P-38A AFW PUMP

- 1.1 The purpose of this modification is to increase the flow capacity of the P-38A AFW pump mini-recirc line and to install flow indication on this line for ASME Section XI testing.

- 1.2 The scope of this procedure is to replace the existing 1-1/2 inch recirc line with a 2 inch line, add a flow orifice and transmitter, and change the setpoints for AF-4007 (P-38A aux feedwater pump recirc line control valve). In addition, two supports in the pump discharge line will be modified.

Step Change/Reason MSS Summary Review  
This IWP installs modification 88-099\*B for the P-38B  
AFW pump. The modification increases the capacity  
of this pump's mini-recirc line and adds a flow  
indicating transmitter to the line

AUXILIARY FEEDWATER RECIRCULATION LINE MODIFICATION  
SK-AFW-009/88-099

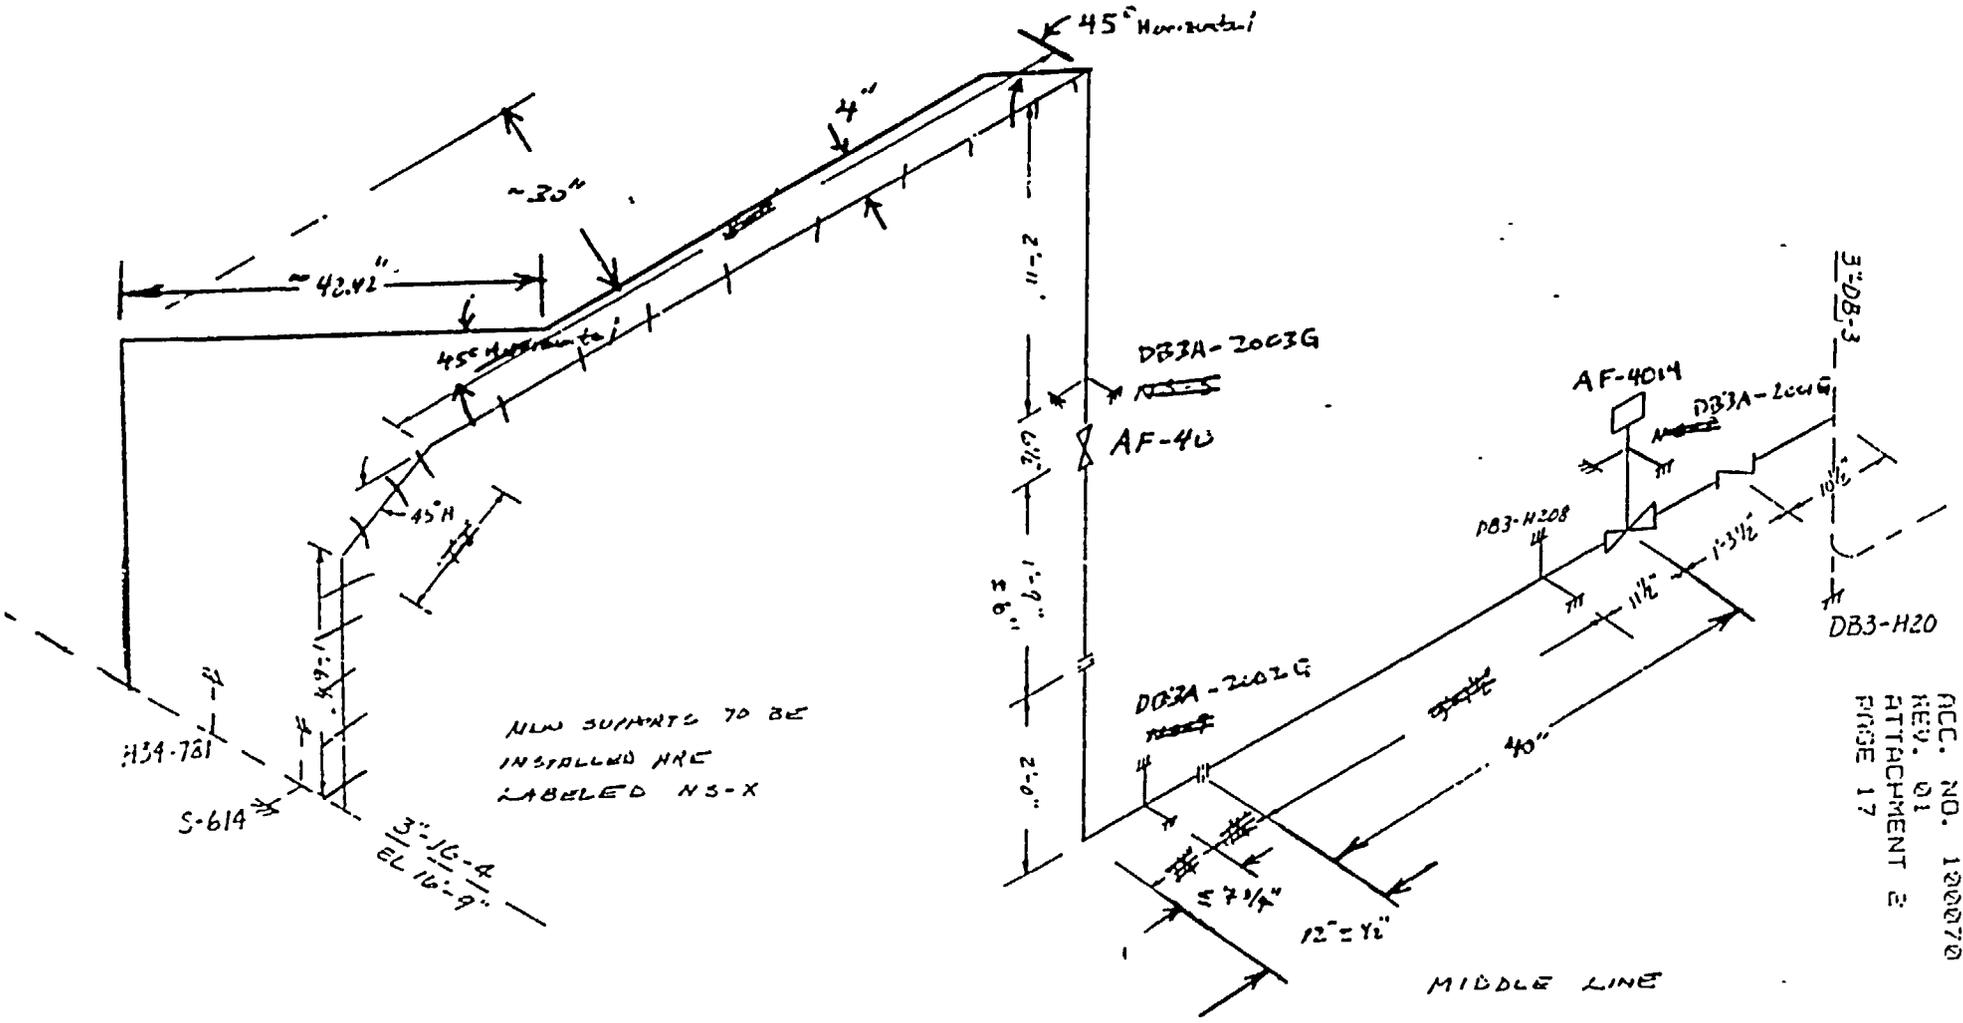
Problem Description and Proposed Change:  
Revision of the piping isometric for the P38B mini-recirc line can not be installed as shown. An existing pipe hanger interferes with the proposed routing in the horizontal section of piping downstream of manual valve AF-40. In addition, the dimensions of the horizontal run downstream of valve AF-001B add up so that the piping sticks into the hallway by approx 18".

Resolution: Revise the dimensions in the horizontal run of piping as shown in the sketch. Delete the existing 45° jog shown in the isometric and add two 45° jogs of approx. 4" and 30" offset as shown in the attached marked-up sketch. Sargent & Lundy has verbally approved of this change. This portion of the piping is Non-QA. Note that the recommendation of a 30" clearance between the control valve and the other things is 20-22 nominal pipe diameter, then the 40" height is within acceptable limits. See the memo from Sargent & Lundy with sketch.

POINT BEACH NUCLEAR PLT. UNIT-2  
 WISCONSIN ELECTRIC POWER CO.  
 MILWAUKEE, WISCONSIN  
 PBA-1070 SH. 5

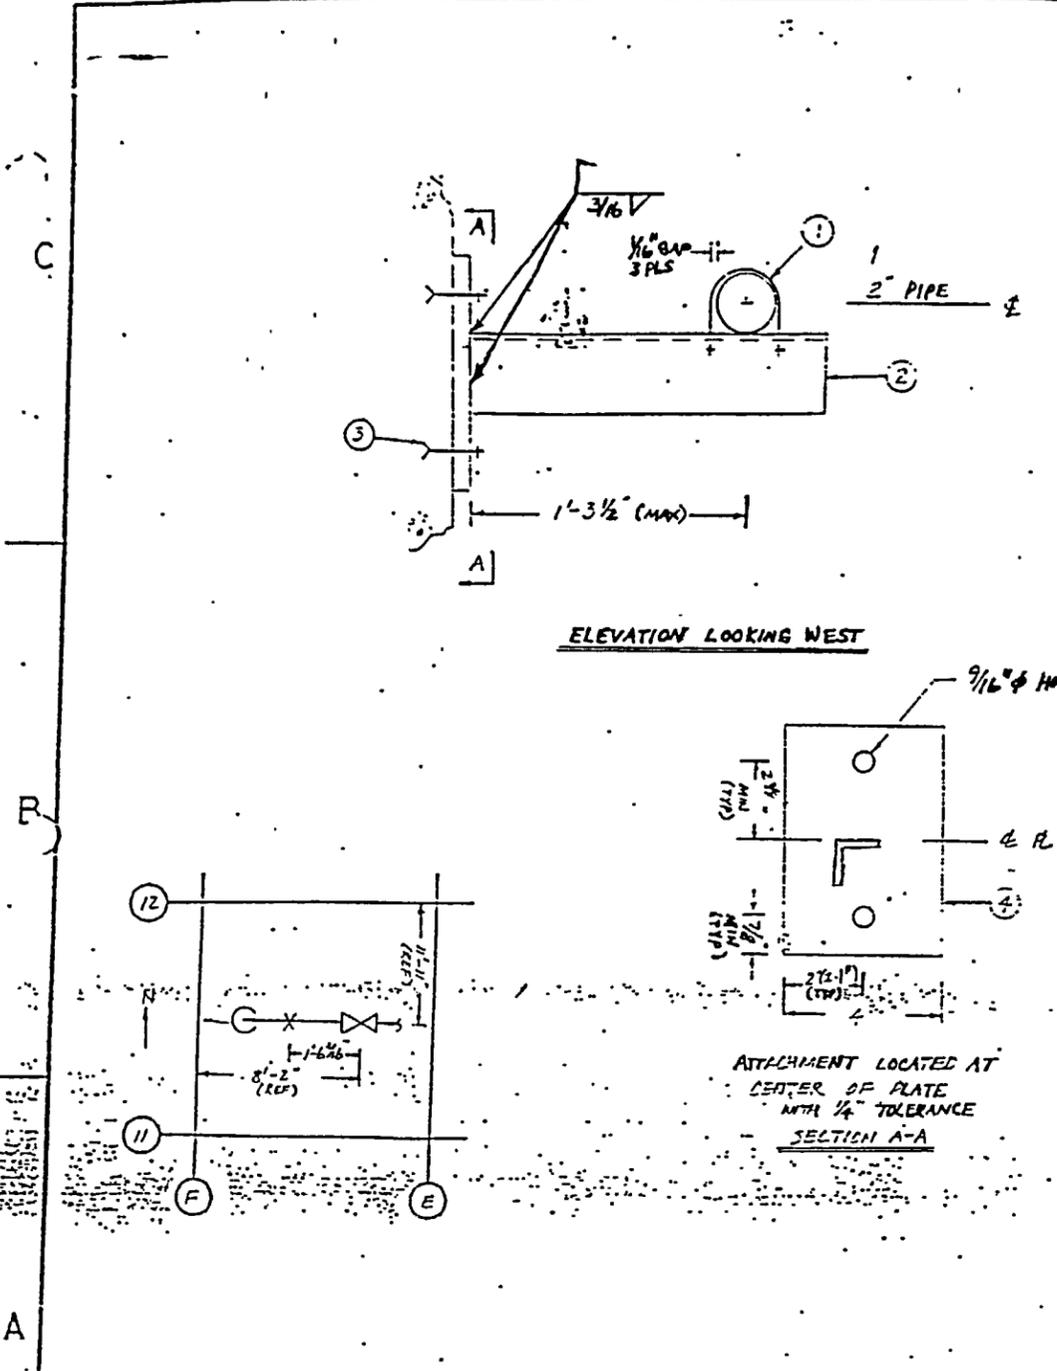
Problem Description and Proposed Change:  
In order to avoid rebar when installing the HULTI bolts for support DB3A-2002G the location of the base plate ended up being approximately 1" higher than it should have been. Since the base plate is at a higher location the angle can not be installed at the horizontal center location ( $\pm 1/4"$ ) as required on Drawing PBA-1070 sheet 5. The angle can be installed with its top face at the horizontal center which makes the distance from the center of the plate to the centroid of the angle approx.  $5/8"$

Change Required: Specs: _____ Procedures: _____ ✓ Drawings: PBA-1070 sheet 5 to be as-built ✓ Other: Include this information in the as-built S&L analysis.	Design Verification Required:	<input type="checkbox"/> Yes <input checked="" type="checkbox"/> No
	Completed:	Date: _____
	MR Addendum Required:	<input type="checkbox"/> Yes <input checked="" type="checkbox"/> No
	Completed:	Date: _____
	10CFR50.59 Evaluation Required:	<input type="checkbox"/> Yes <input checked="" type="checkbox"/> No
	Completed:	Date: _____
	Resolution By/Date:	John A. Schroeder 9/18/91
